GRADING EROSION CONTROL PLANS

FUEL STATION #4335

FALCON, CO

Sheet List Table		
		Sheet Title
1	OF 11	GRADING EROSION CONTROL COVER SHEET
2	OF 11	GRADING PLAN
3	OF 11	GRADING & EROSION CONTROL NOTES
4	OF 11	SWPPP NOTES
5	OF 11	SWPPP IMPLEMENTATION SEQUENCE
6	OF 11	PHASE I EROSION AND SEDIMENTATION CONTROL PLAN
7	OF 11	PHASE II EROSION AND SEDIMENTATION CONTROL PLAN
8	OF 11	SWPPP IMPLEMENTATION SUMMARIES
9	OF 11	SWPPP DETAIL SHEET 1
10	OF 11	SWPPP DETAIL SHEET 2
11	OF 11	SWPPP DETAIL SHEET 3

GRADING EROSION CONTROL COVER SHEET  
SHEET TITLE  
SHEET NUMBER

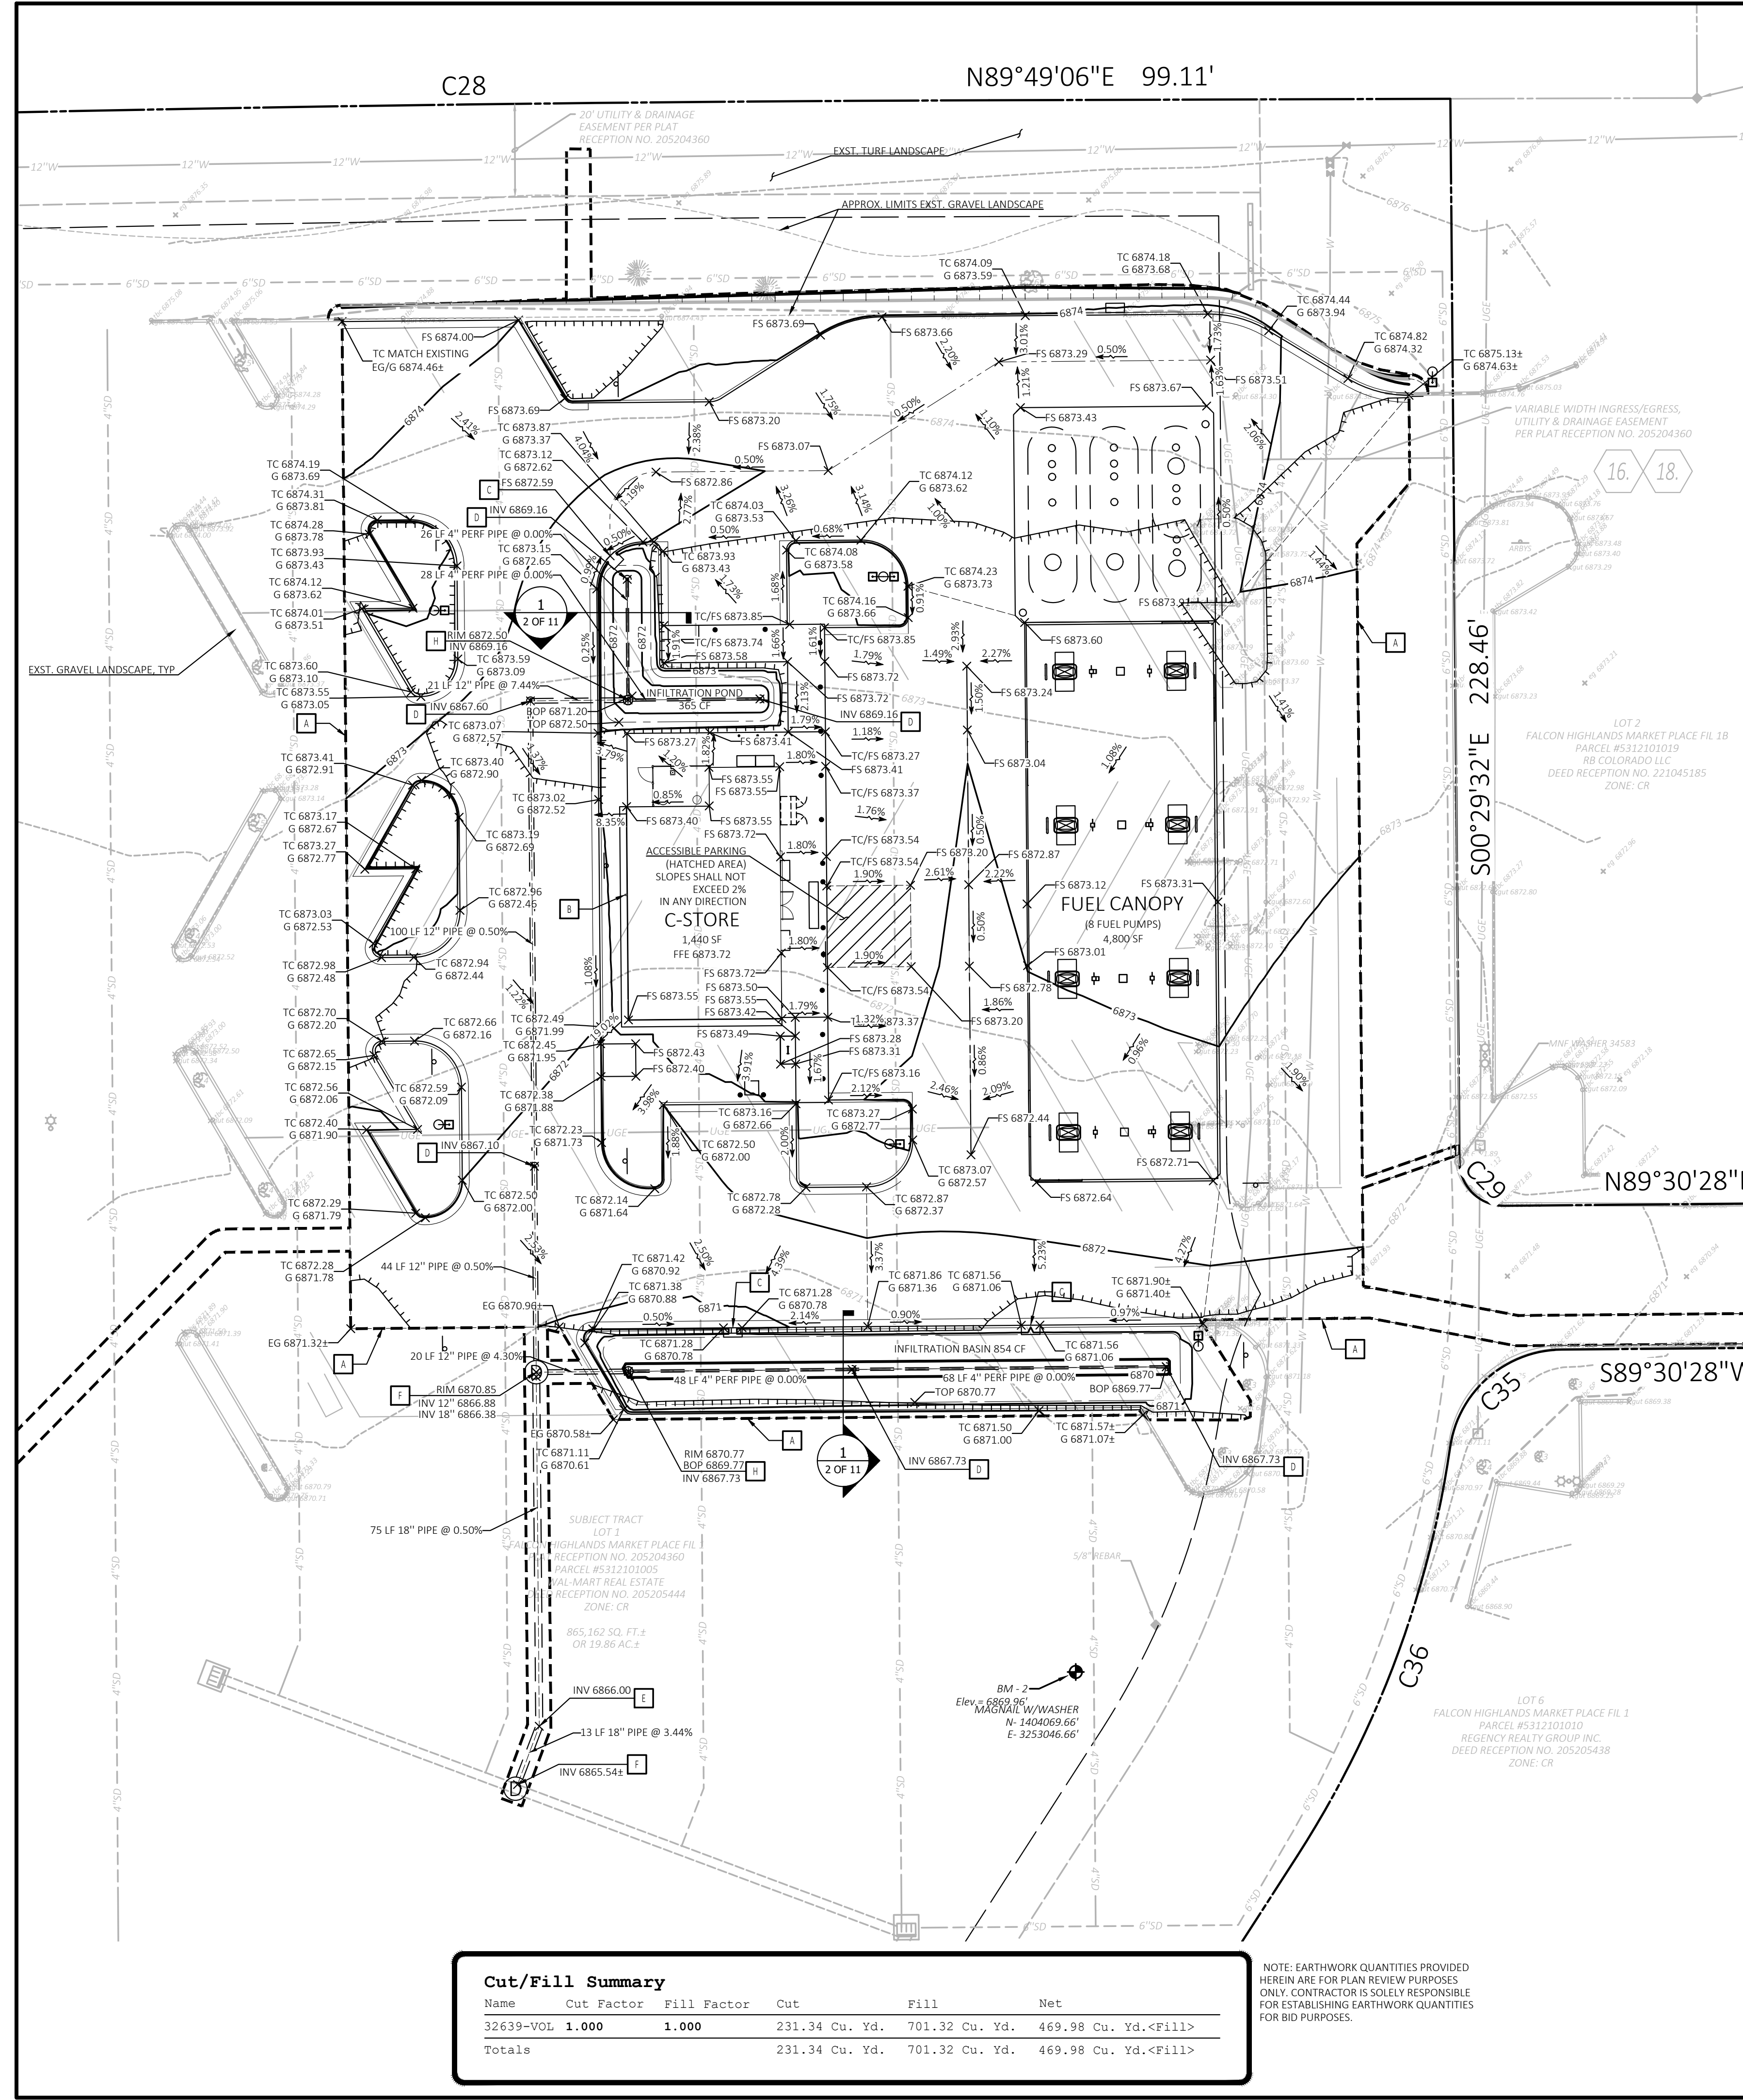
Revise to "Joshua Palmer, P.E."

Add text:  
EPC's EDARF Filing #:  
PPR2324

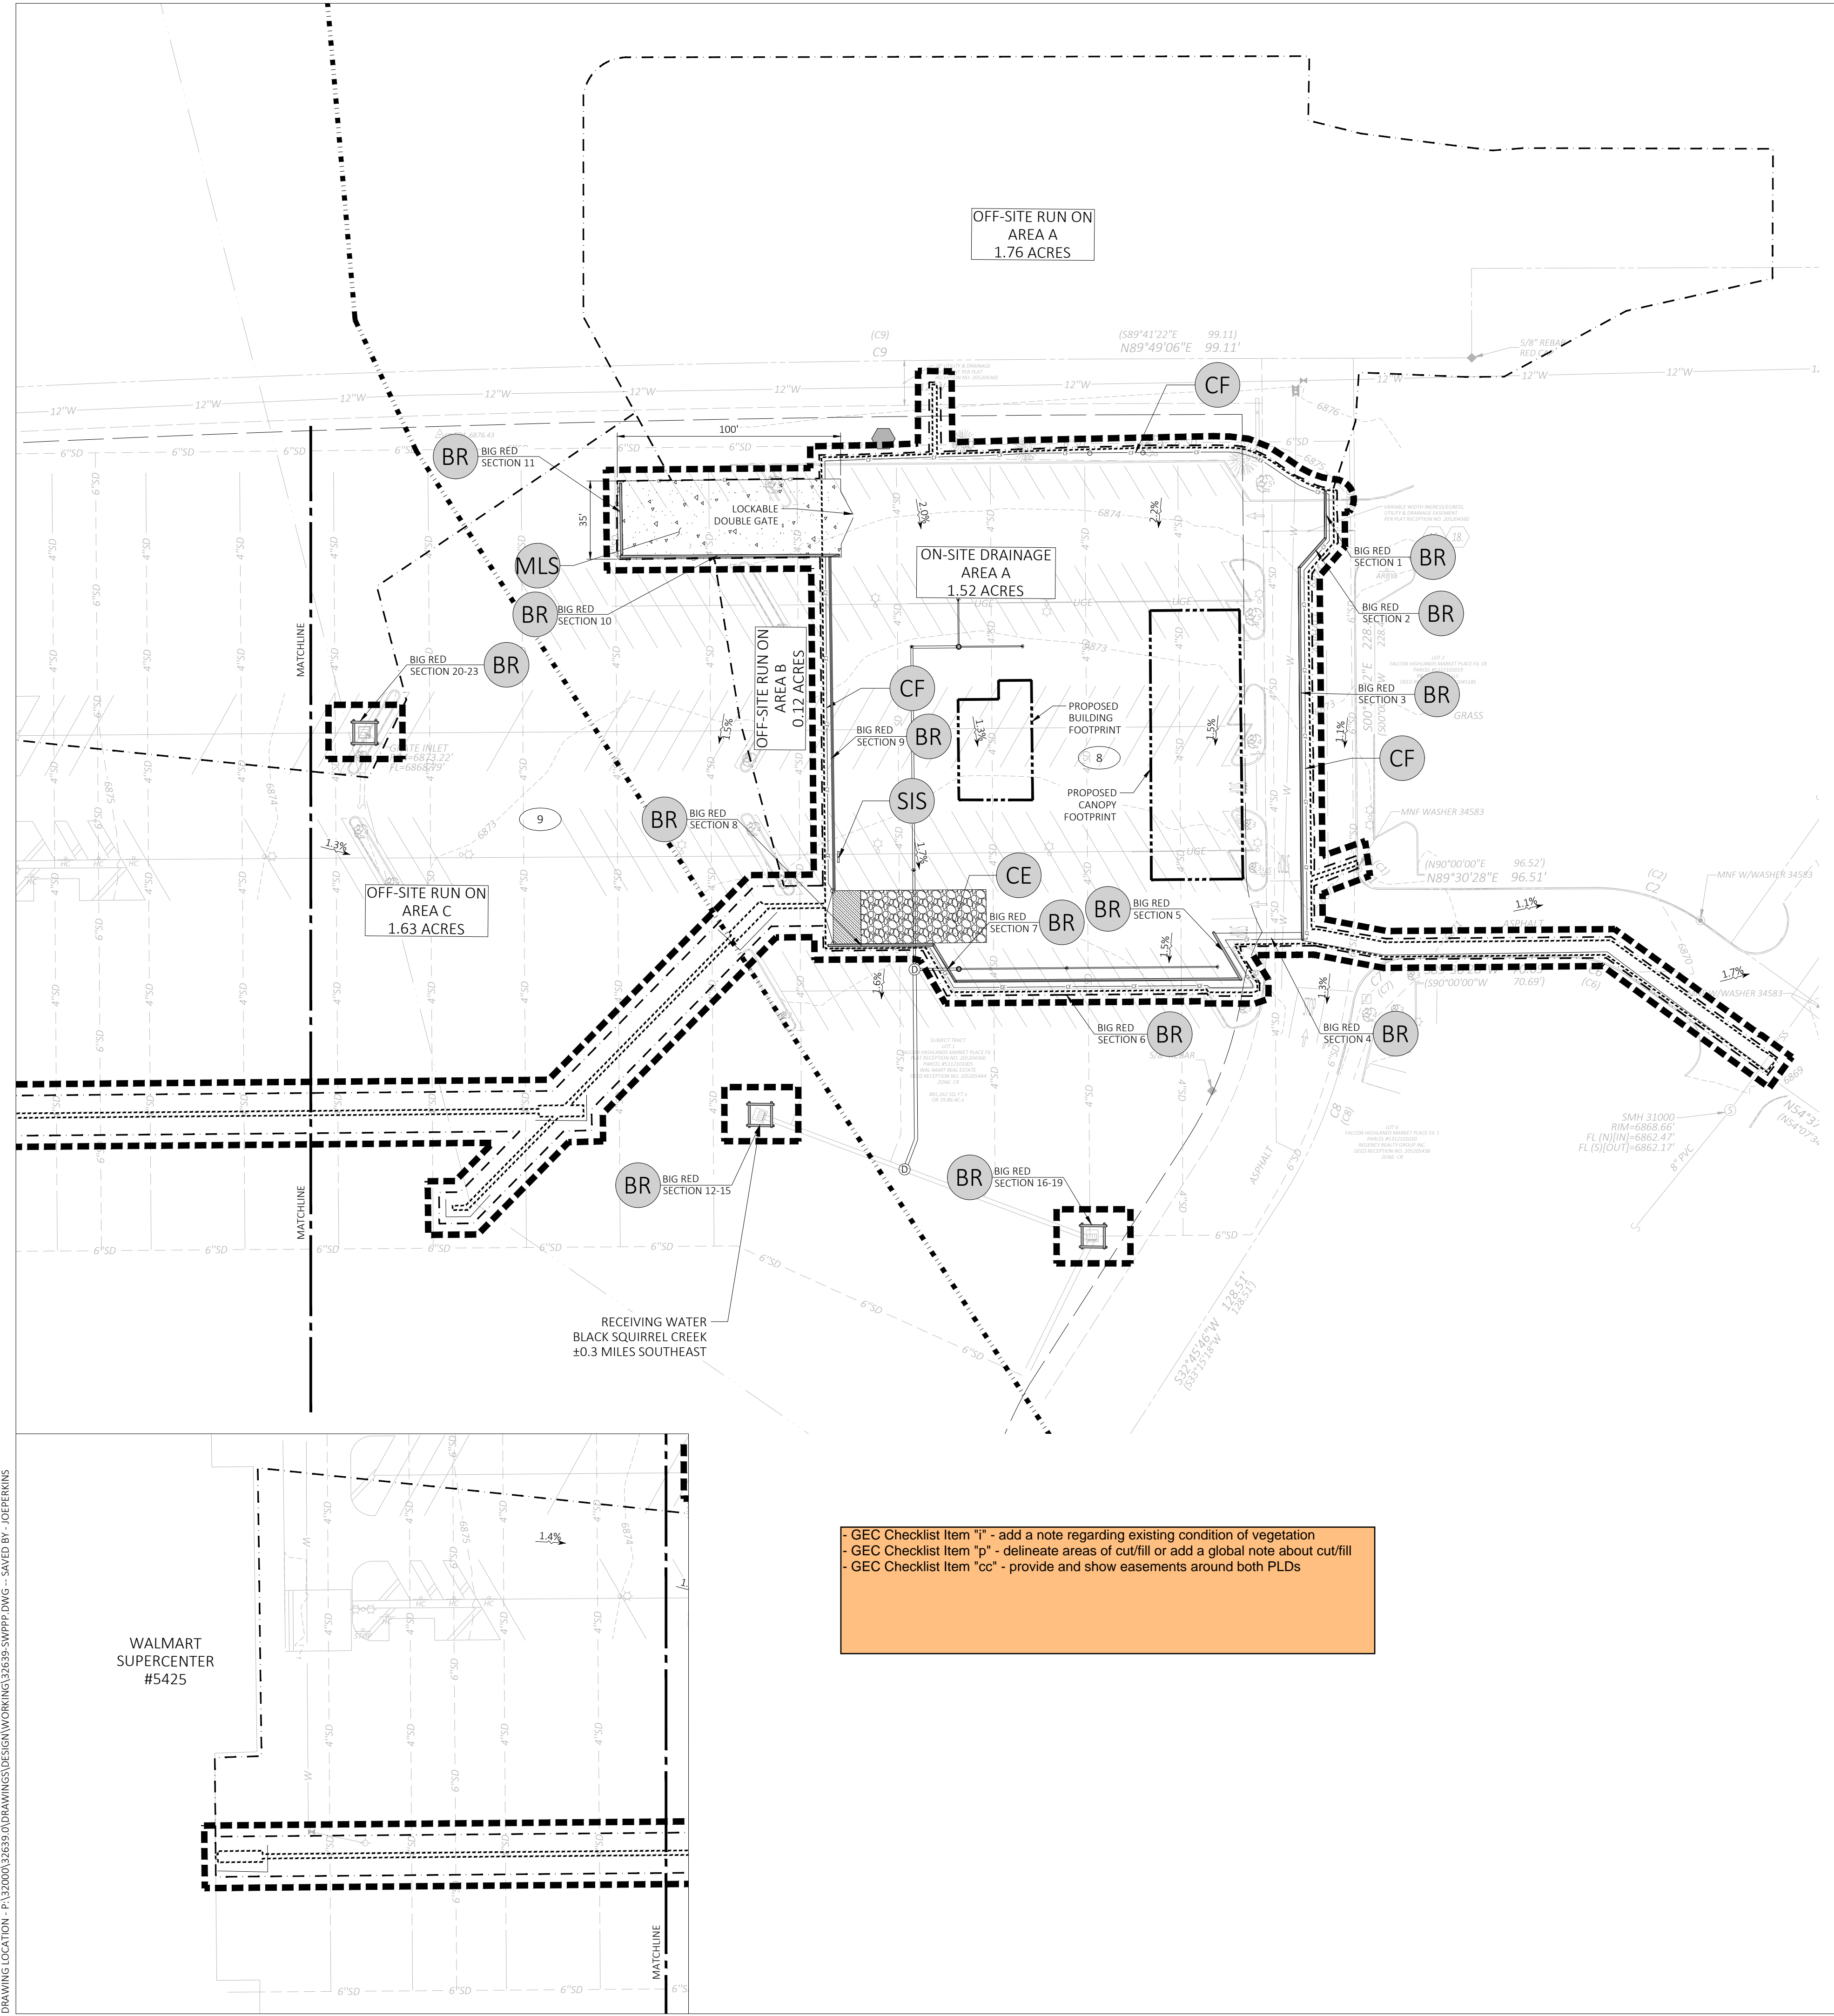
- GEC Checklist Item "i" - add a note regarding existing condition of vegetation  
- GEC Checklist Item "p" - delineate areas of cut/fill or add a global note about cut/fill  
- GEC Checklist Item "cc" - provide and show easements around both PLDs
